CITY OF BELOIT REPORT TO THE BELOIT LANDMARKS COMMISSION

Meeting Date: November 18, 2008	Agenda Item: 4	File Number: COA-2008-31
Applicant: Ann Reinert	Owner: Ann Reinert	Location: 861 Bluff Street
Existing Zoning: R-1B, Single-Family Residential District	Existing Land Use: Residential - Duplex	Parcel Size: 7,392 square feet

COA-2008-31

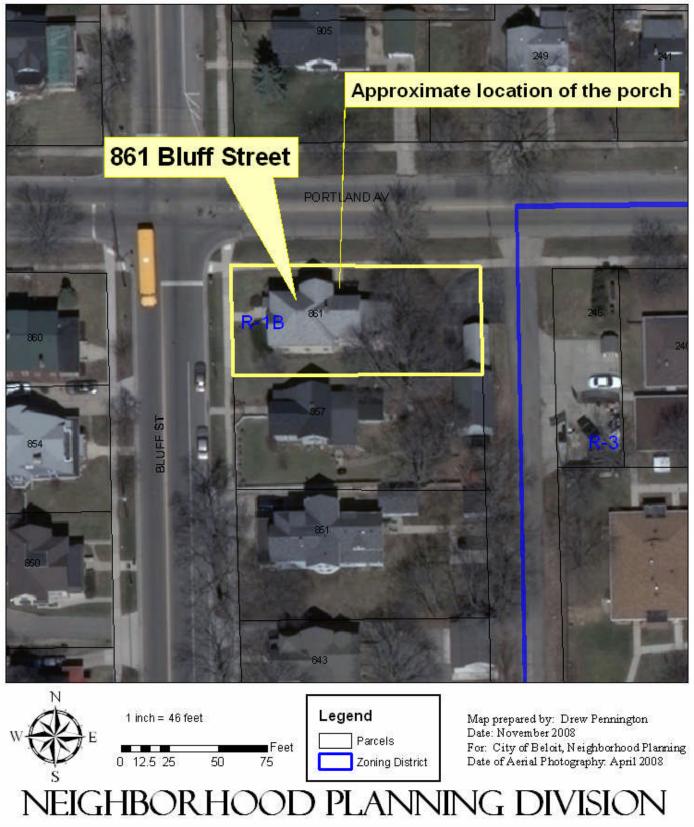
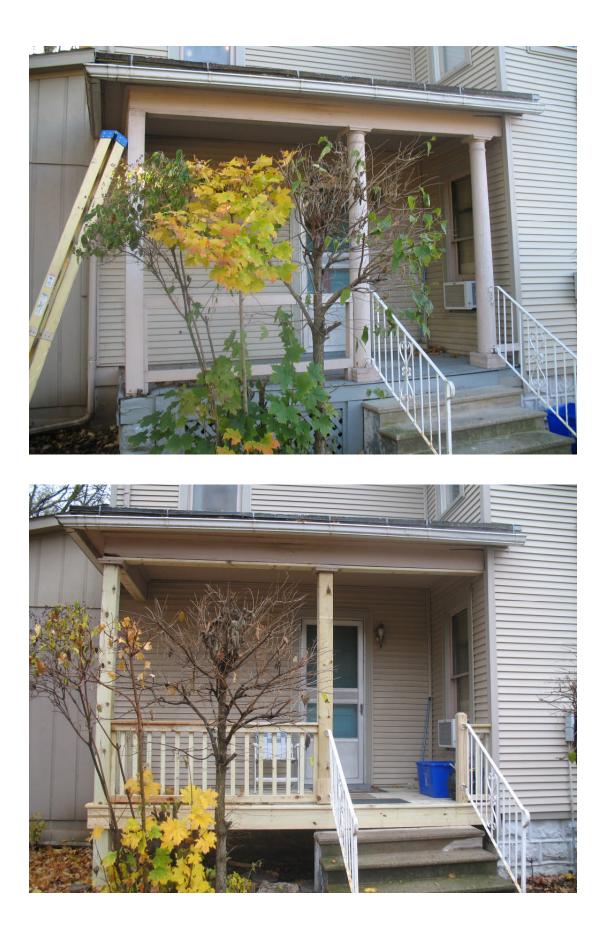
- As shown on the first photo, one of the three original porch columns was replaced with a pillar. This was done before 1991, as the pillar is present in the Intensive Survey photos of this house. Unfortunately, this pre-1991 project resulted in a lack of symmetry and consistency that has lasted until today.

- Staff believes that the proposed actions, subject to certain conditions, satisfy the standards of Section 32.06(6)(c).
- On a recent visit to the subject property, staff discovered that the applicant's contractor had replaced the columns with a pillar. As stated in the staff-approved COA, this was done with full knowledge that the Landmarks Commission may not approve the request to replace the columns with a pillar. Please see the attached COA for additional information. As shown on the attached photo, both new pillars include a square capital.

The Neighborhood Planning Division recommends *approval* of a Certificate of Appropriateness to replace two porch columns with a pillar on the house located at 861 Bluff Street, subject to the following conditions:

- 1. The porch shall be painted to match the house. The color shall be one of the colors presented in the City's Historic Preservation Guide.
- 2. The porch skirting shall be replaced with like materials and painted accordingly.
- 3. All work must be completed by December 31, 2008.
- 4. Any changes or additions to this Certificate of Appropriateness must be reviewed and approved by staff prior to the start of any work. Work done without prior approval will be subject to the issuance of correction orders or citations.
- 5. The applicant must obtain all necessary building permits. The completion date above does not extend any other time limits, such as those imposed by an order from Housing Services.
